**Re: 657 - 769 Mamre Road, Kemps Creek  
“The Yards” - SSD 9522 Mod 2**

Further to your request we are pleased to provide this letter in relation to a proposed modification (Mod2) to SSD 9522 as approved 21 December 2020. The proposed Mod2 Application is for a change to the approved road cross section including the road reserve, verge and road carriageway arrangements, from those included in the current approval.

**Table 1. Estate Road Cross Section per SSD 9522**

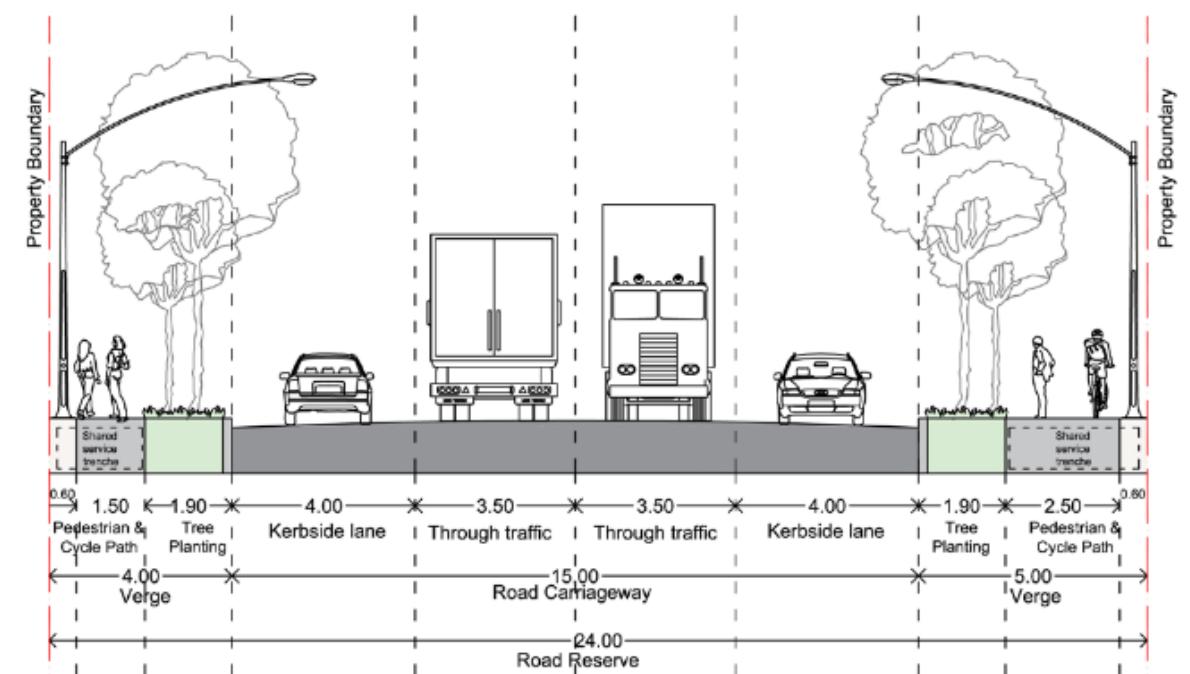
The current approved road cross section is based on a Collector Road with 5m central median as per Figure 13 of the DRAFT Mamre Road Precinct DCP. The development was approved in December 2020 with the larger road cross section, based on the DCP arrangement, as the traffic modelling was not yet completed and as such the road hierarchy was not fully defined at the time of the approval.

**Table 1** shows the approved road cross section arrangement which was adopted for all roads in the estate.

**Table 2. Estate Road Cross Section – Proposed Mod2**

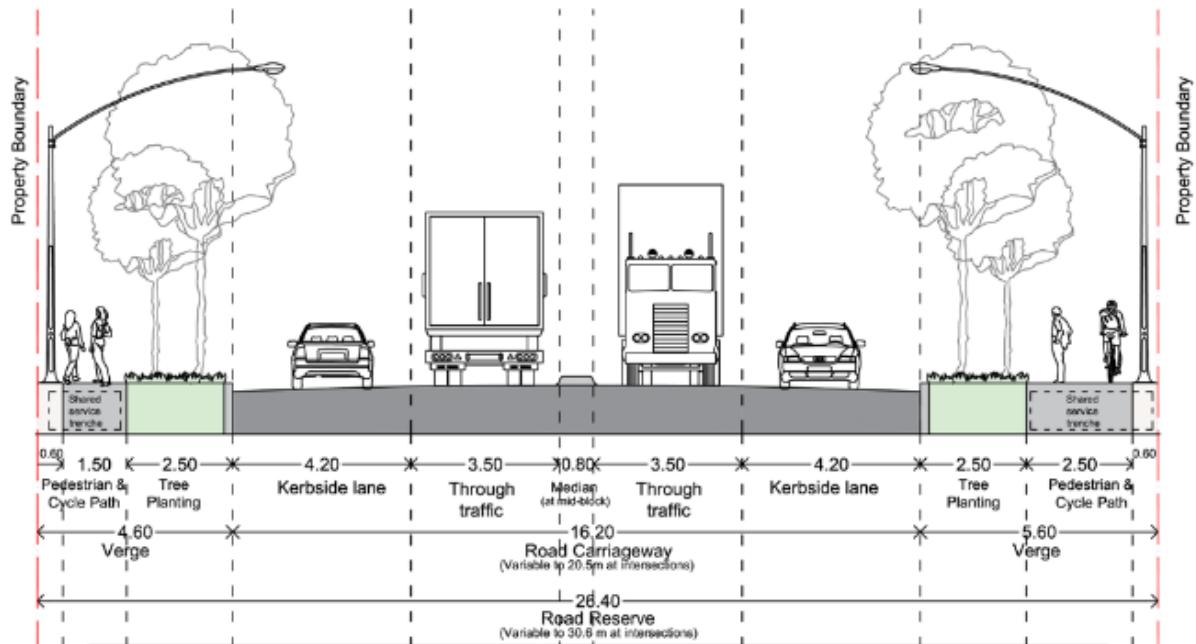
**Table 2 and Figures 2 & 3** show the proposed road cross sections included in the SSD9522 Mod2. It is noted that provision for a 0.8m wide median is included in the distributor road section however not proposed for construction.

A 1.2m wide median is proposed to be installed within the industrial cul-de-sac between Lots 6 and 8 to ensure left in and left out movements for all property entry and exits within the cul-de-sac. This arrangement has been consulted with Council and DPIE and agreed between the parties.
